ERRATA

Technical Manual ME-1653

Distribution Amplifier Model 203-3

Req. Source: EC 2276-404B/G/J

ELEC APPD	DATE	BOZEMAN	MONTRONICS, INC.	MONTANA
MECH APPD		POWER SUPPLY		
CHECKED				
DRAWN				
DESIGN APPROVAL		CODE IDENT NO.	SIZE B	203-3-101
		SCALE		SHEET

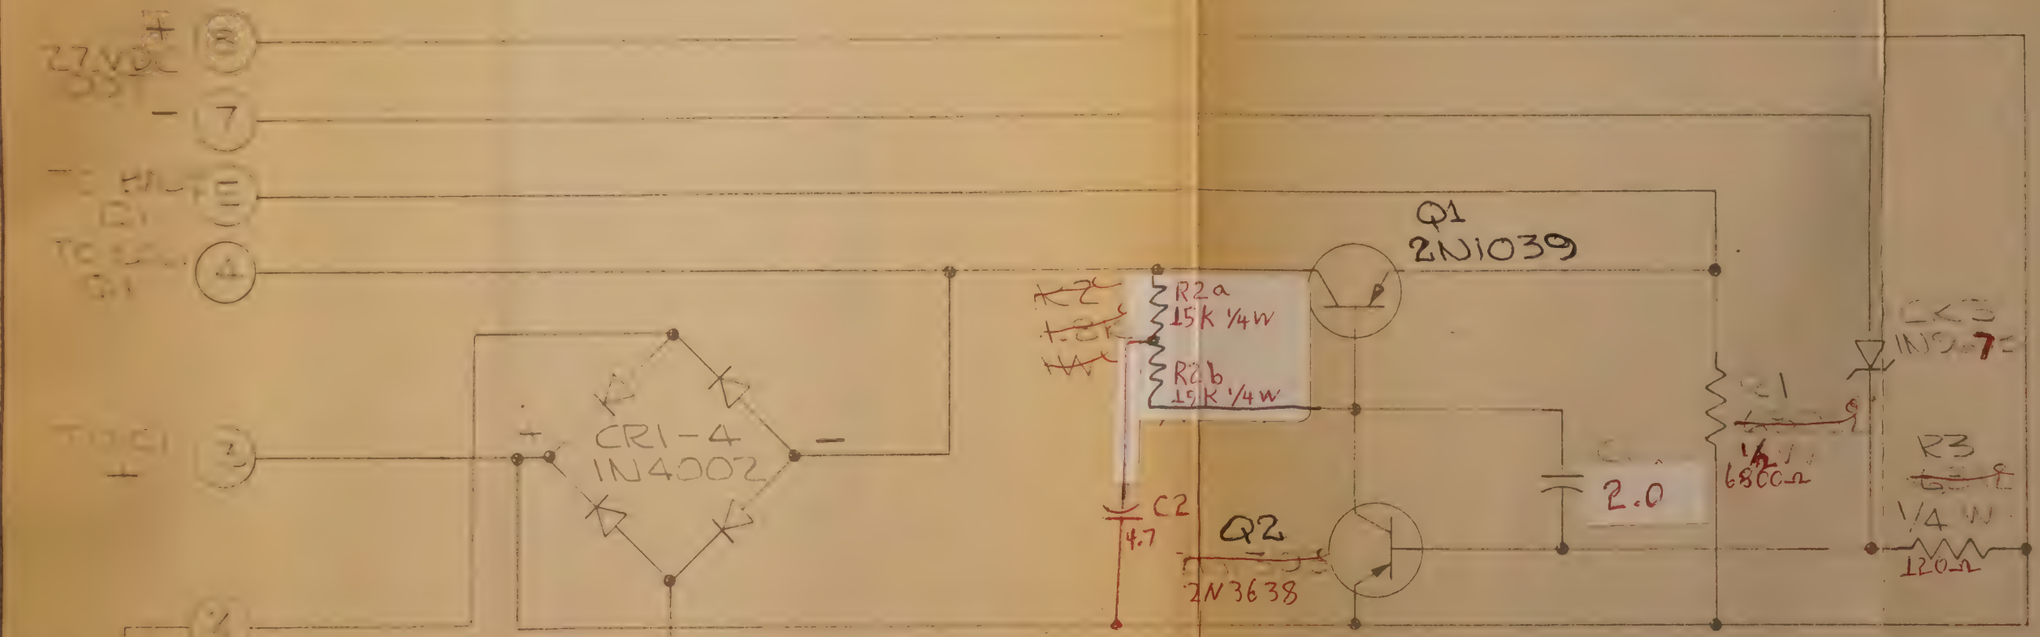
9. Drawing 203-3-101. Change the drawing as indicated below.

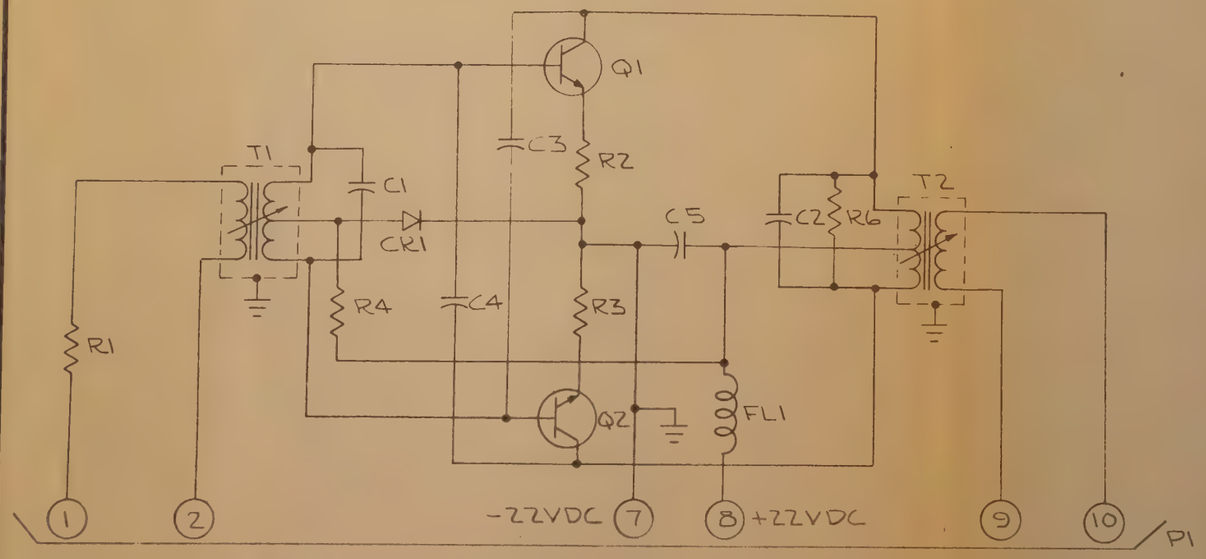
6. Drawing 203-3-102/103/104, 5mc, 1mc, .1mc Pre-amplifier. In the 203-3-104 column of the parts table, for CR1, change "1N483B" to "1N3728."

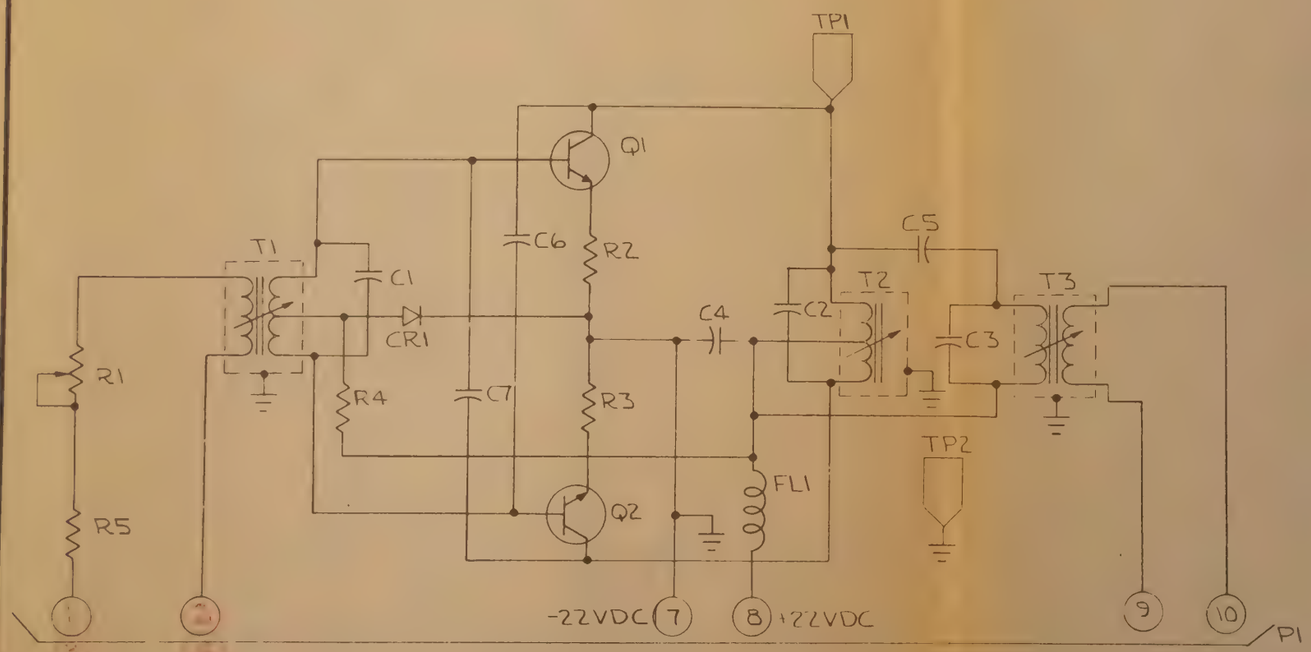
7. Drawing 203-3-105/106/107, 5mc, 1mc, .1mc Amplifiers. In the 203-3-105 column:

a. For C4 change ".05UF" to "2.0UF."

b. For R4, change "68K" to "15K."

CHASSIS WIRING DIAGRAM

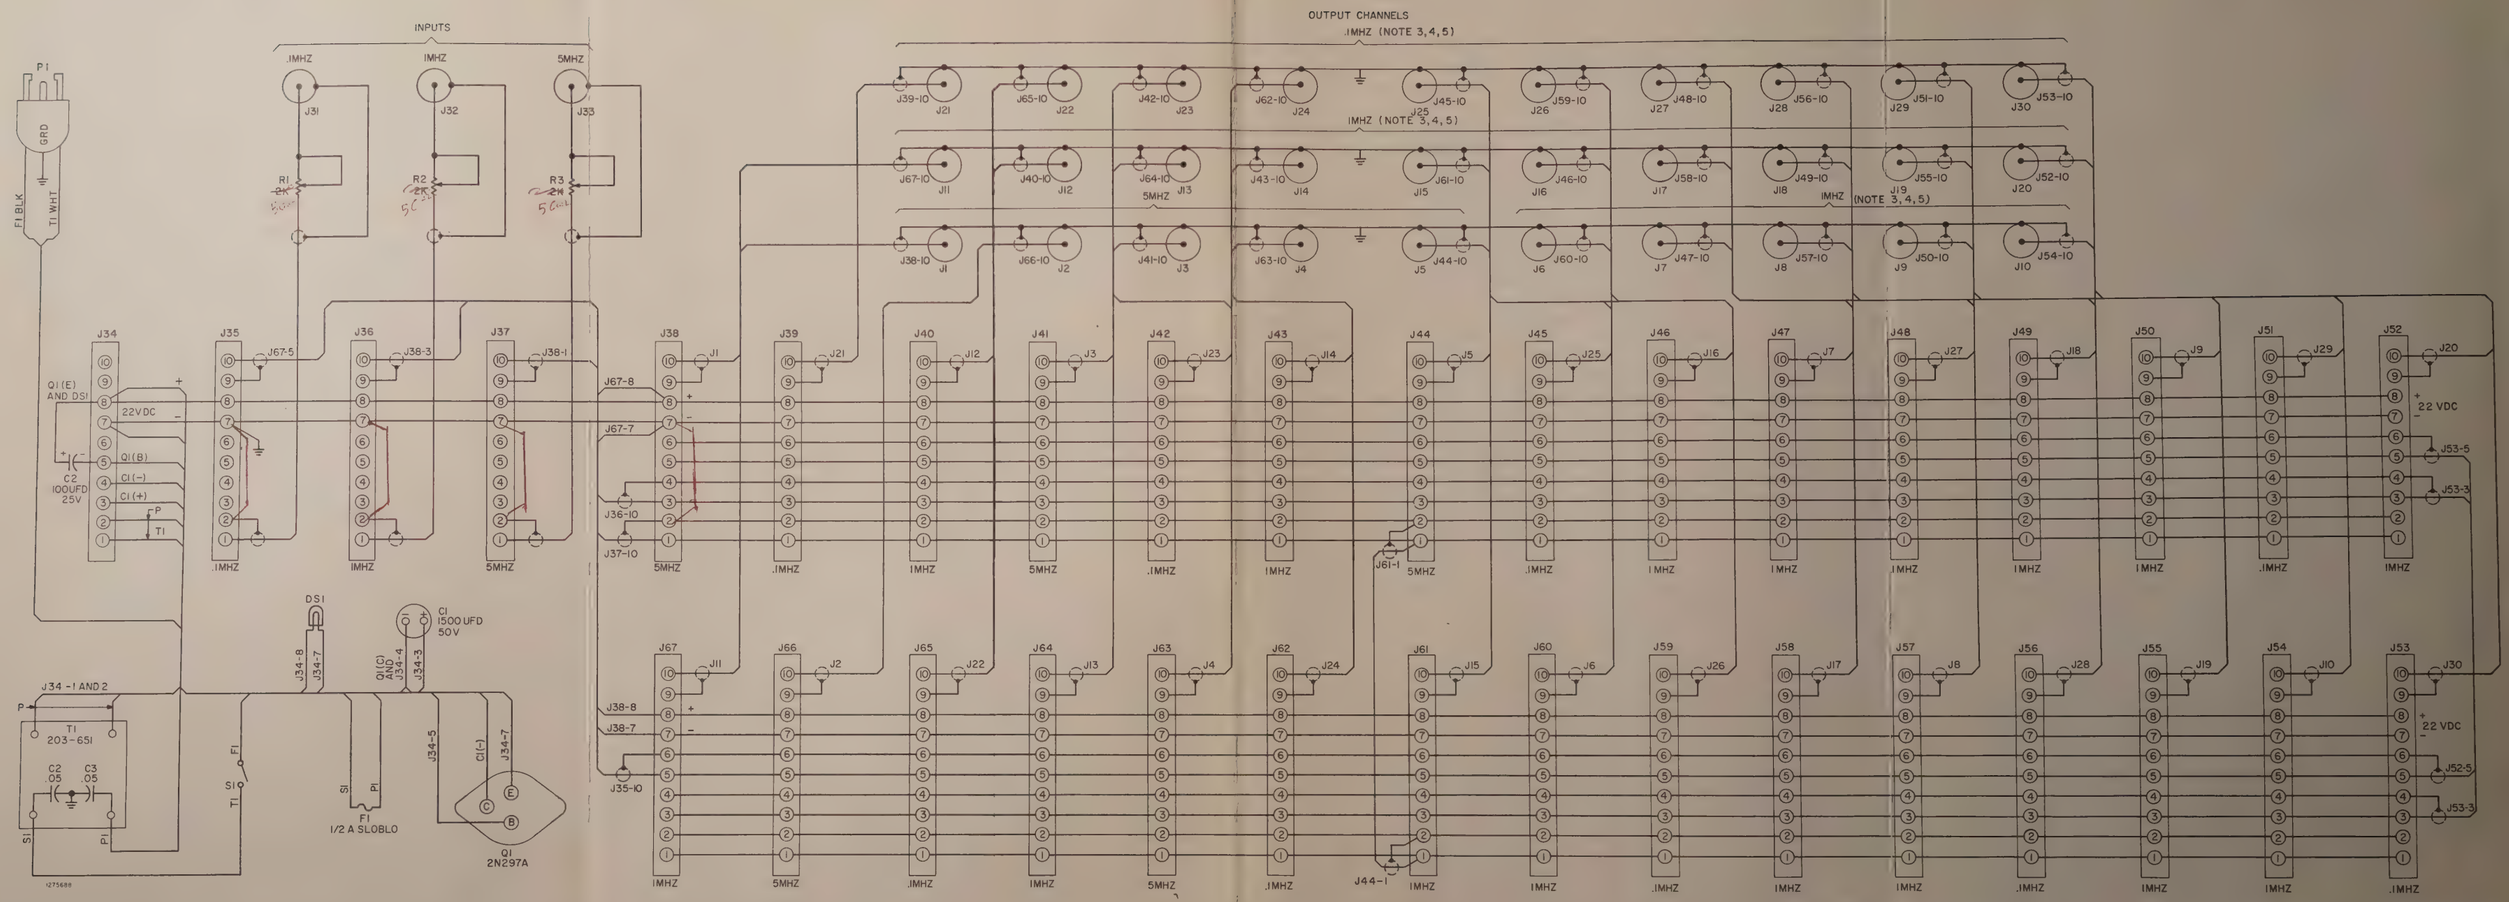
8. CHASSIS WIRING DIAGRAM.

a. R1, R2, R3. Change "2K" to "50Ω."

b. J35, J36, J37, J38. Draw a line connecting J35 pin 2 to J35 pin 7; connect pin 2 to pin 7 in a similar manner on J36, J37, and J38.
